POLICE ACADEMY  
HILLA, IRAQ

**SIGIR PA-05-032**  
**JANUARY 31, 2006**

SUBJECT: Report on Project Assessment of the Police Academy, Hilla, Iraq  
(Report Number SIGIR-PA-05-032)

## Police Academy in Hilla, Iraq

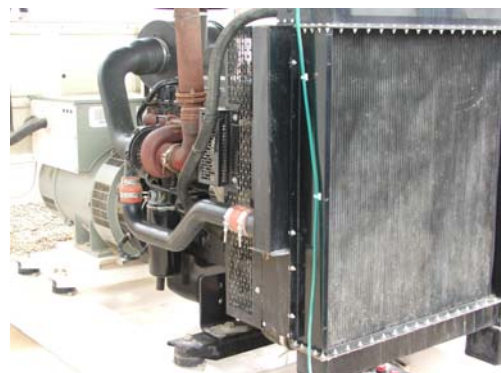
Section 5.15.5 of the SOW required the contractor to provide an electrical power supply and distribution survey on the existing conditions and an electrical power supply and distribution design. A review of the contract files show the contractor provided neither.

Further, Section 5.9 of the SOW required the contractor not to begin construction until the Government's Project Engineer approved the contractor's design. A review of the contract file and discussions with JCC-I/A indicate the Government did not appoint a Project Engineer nor was a project design submitted for the electrical distribution system.

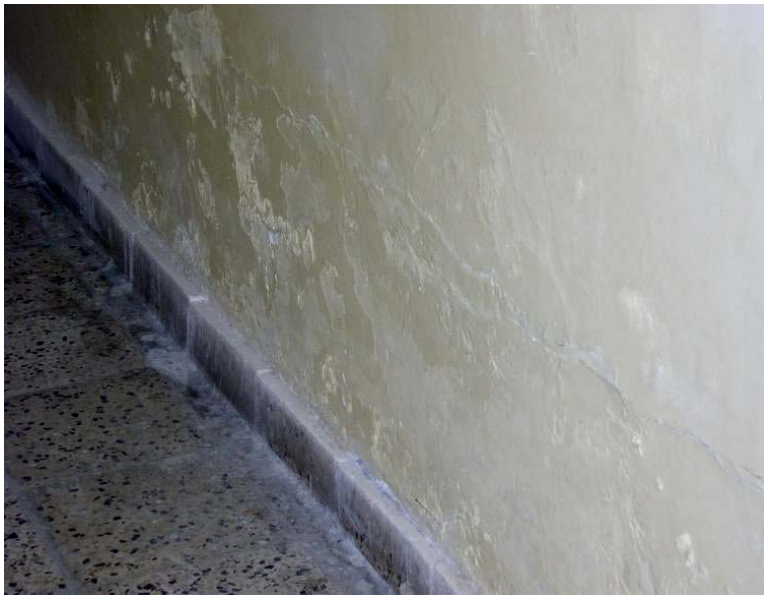
Section 5.15.5 of the SOW required the contractor to submit a trailer design for the living quarters. This section of the SOW also required a submittal for the bathroom fixtures to include toilets, sinks, faucets and showerheads. We reviewed the contract file and did not find a submittal regarding the living quarters or the bathroom fixtures.

In our onsite review, we looked at one of the instructor rooms, the lounge, and one of the bathrooms; all appeared to be in serviceable condition. However, we observed only one telephone in the lounge area. Section 5.4 of the SOW required 10 phones for the lounge area.

**Site Photo 12. Grinder Pump Basin with Close-up of Pump**

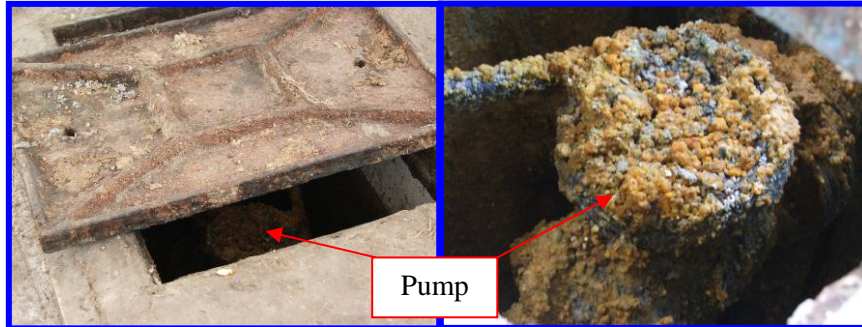
**DABV01-04-M-8070:** The wastewater facility did function as the contract required. The contractor did not resolve the design, capacity, and operation issues. Although, the system was designed to operate with two pumps, only one pump was installed.

The contract originally called for a wastewater lift station with a grinder pump (and a backup pump) capable of transferring effluent 500 linear feet from the camp to the nearest city sanitary sewer manhole; our assessment showed one pump. The wastewater

is not pumped to a city sanitary sewer manhole but it is pumped to wastewater collection tanks on site where it is stored until collected by vacuum trucks. Site Photo 12 shows the grinder pump basin and a close-up of the pump. The pump is entirely encrusted with deleterious material deposits which indicate no preventive maintenance was performed.

**Site Photo 15: 615 KW Generator at the Hilla Police Academy**

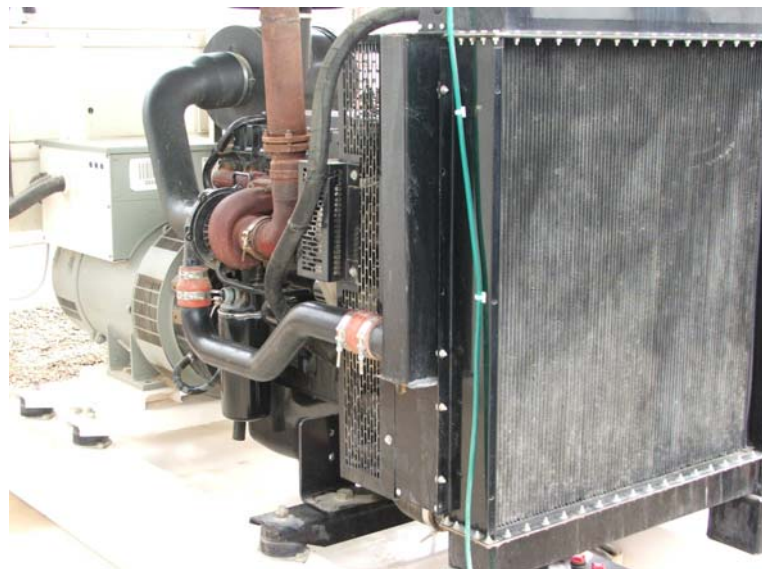
**DABV01-04-M-8326:** The contractor did not deliver or install the two generators. In addition, GBG removed one generator for overhaul and it was not returned.

SIGIR Audit Report 05-16, notes that three generators were purchased for the police academy -- two 500-kilowatt generators and a one-megawatt generator. The report mentions that the one-megawatt generator and one of the 500-kilowatt generators had not been delivered. Further, the 500-kilowatt generator that had been delivered was offsite for repairs. We observed two generators during our site visit. While onsite, we ascertained that GBG had not supplied either one. The larger generator, shown in Site Photo 15, is rated at 615 kilowatts according to factory plate information.
